# FACPAC Contract Change Order Supplemental Information Form (Ref# 60467)

Tier 1 Project: Phase 6 Additions and Renovations - Project #175-520

CHANGE ORDER NUMBER: 216-06  
 INITIATION DATE: 8/1/2024

Additional cost to add floor boxes in Video Room 129. \$14,831  
 Additional cost to add theater lighting and LED logo. \$23,603  
 Additional cost of adding power and data in various locations. \$60,726

**E204**

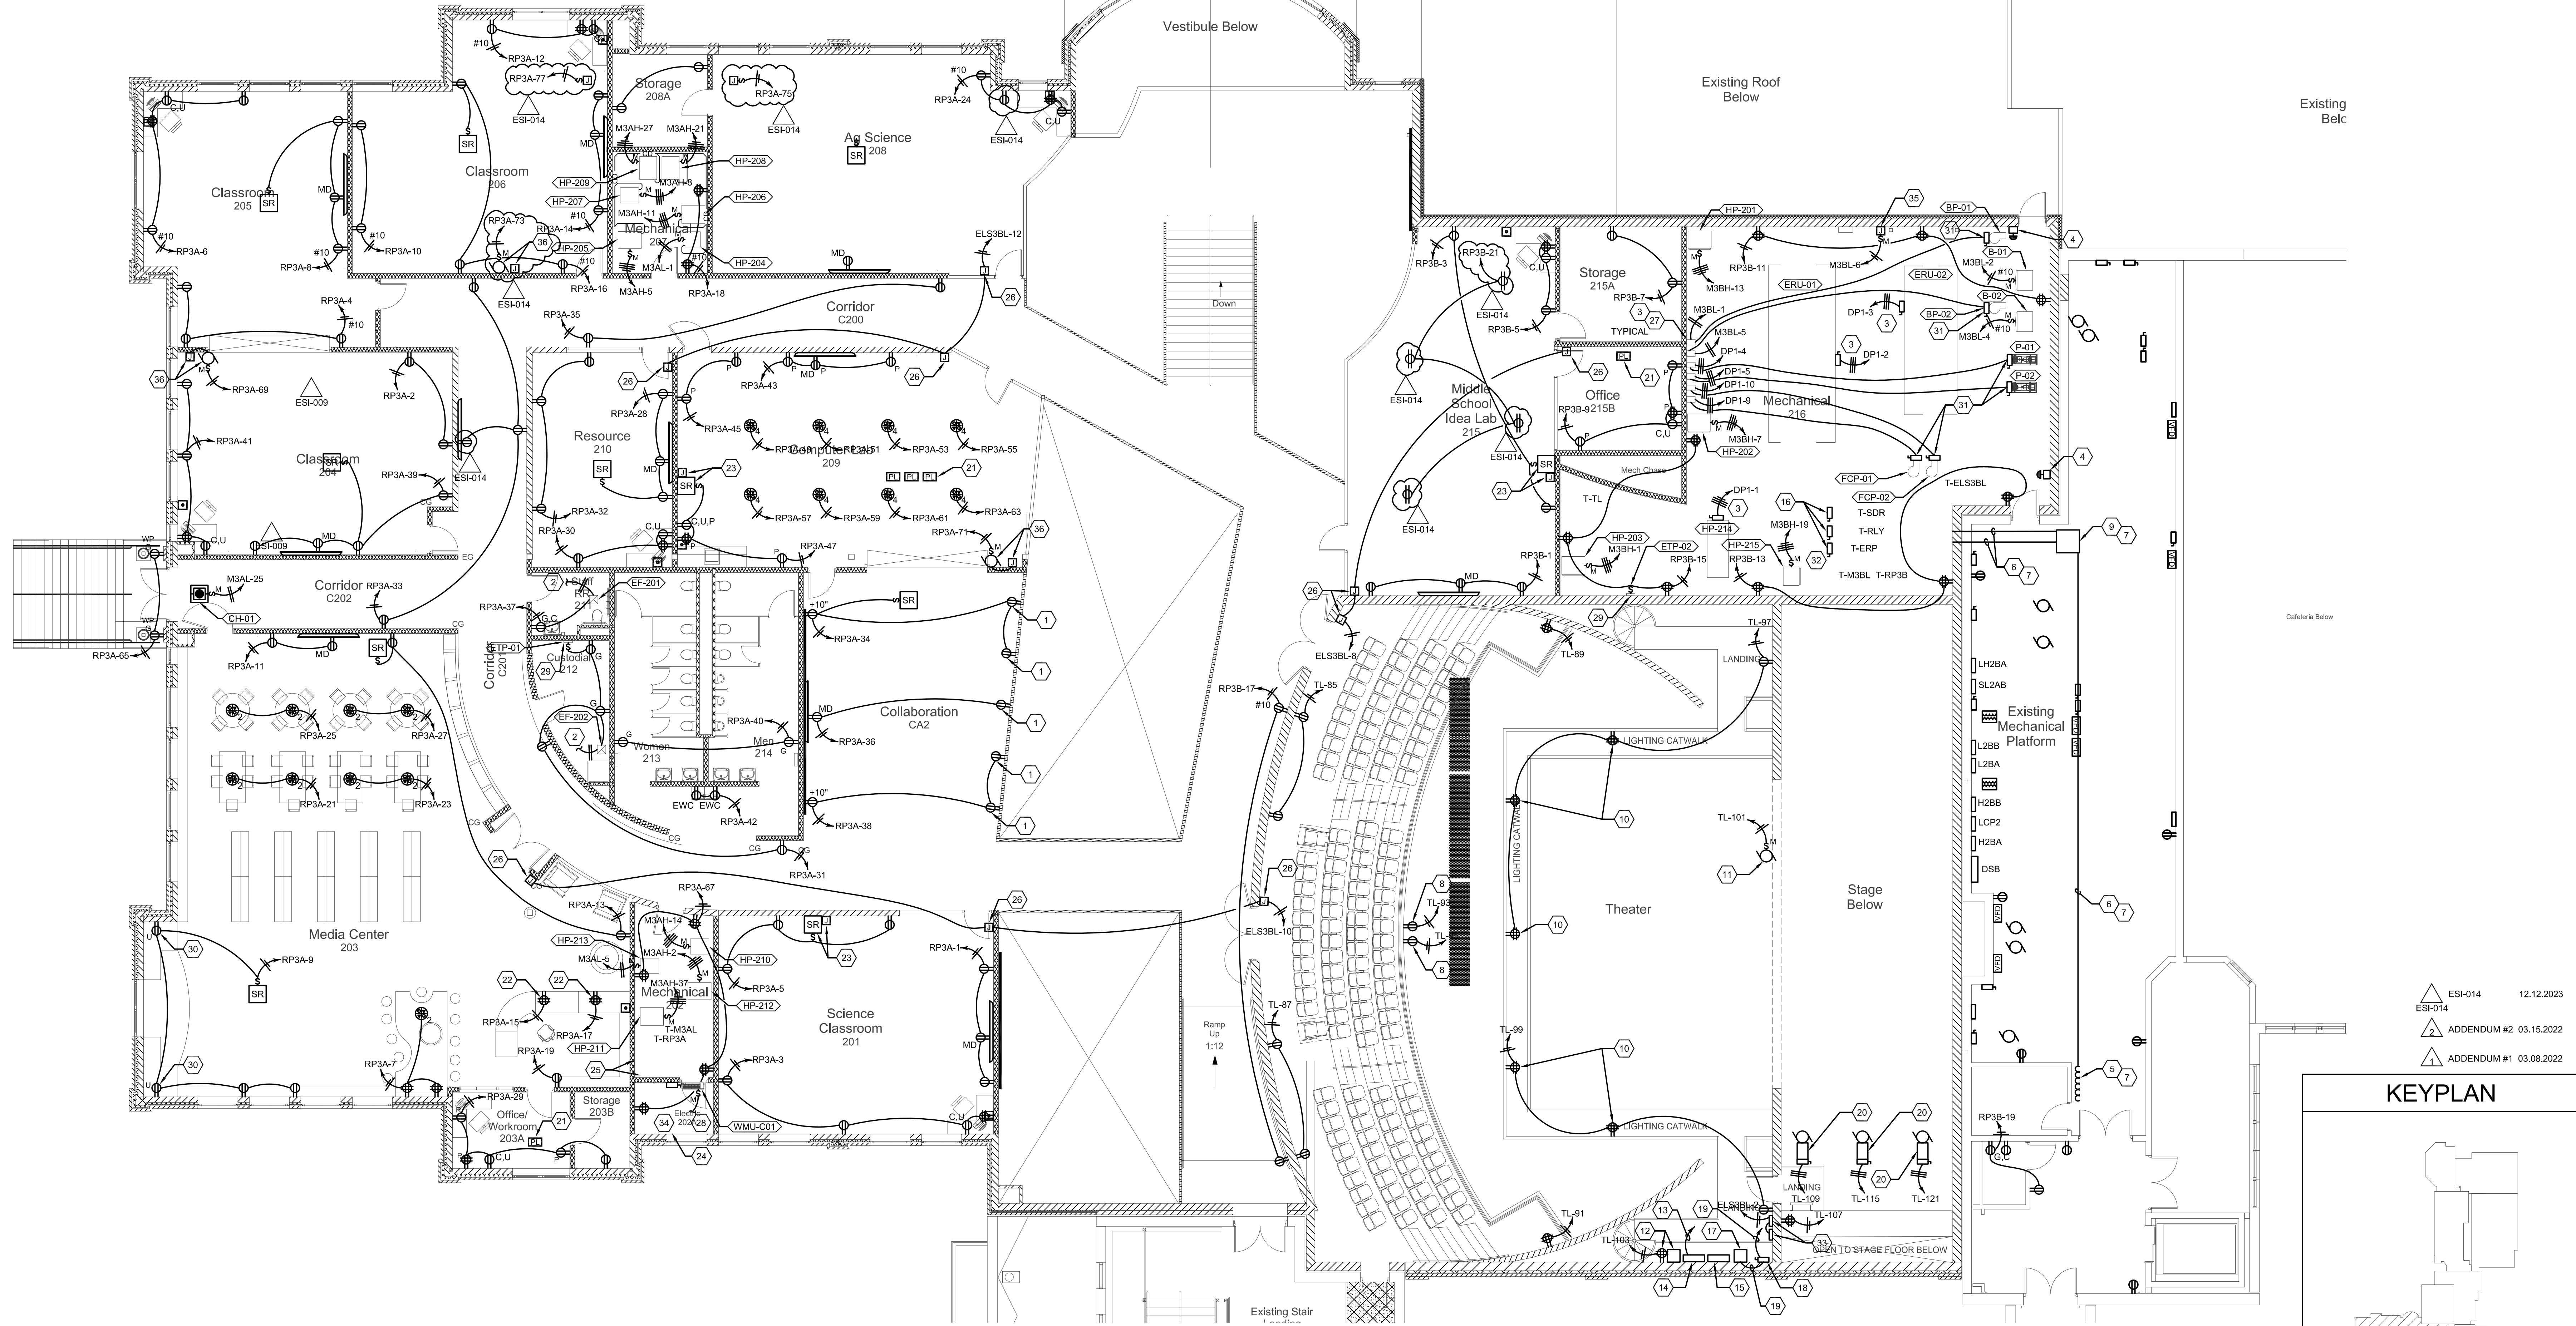
Electric changes in Media Center 134 (STW ESI #14)  
Reference sheet E202:  
Added power for TV's in rooms 102, 104, and 105.  
Added USB receptacles and circuits on Social Steps 134B.  
Reference sheet E204:  
Added power for TV in corridor C201.  
Added power and circuiting for horizontal ticker screens in rooms 206 and 208.  
Added power for vertical wall TV in room 208.  
Added power and circuiting for garage door in room 206.  
Added poke thru receptacles and circuiting in room 215.  
Reference sketch E204A:  
Added wiremold, power, and data for computer stations in room 208.  
Added Panel RP2C and 45 KVA Transformer T-RP2C in room 208 for computer station circuits.  
Reference Sheet E304:  
Added data drops directly adjacent to ticker receptacles.  
Reference sheet E501:  
Details referring to surface raceway added in room 208.  
Reference sheet E601:  
Panel RP2C and T-RP2C added to one-line diagram.
